<u>Contents</u>

• Interface parameter updates since the last time

Transmission monitor system

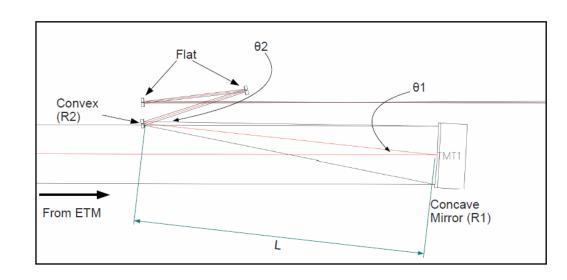
The values used to be... undetermined New values are... partially determined

<u>Influence</u>

- Layout update
- WFS sensitivity
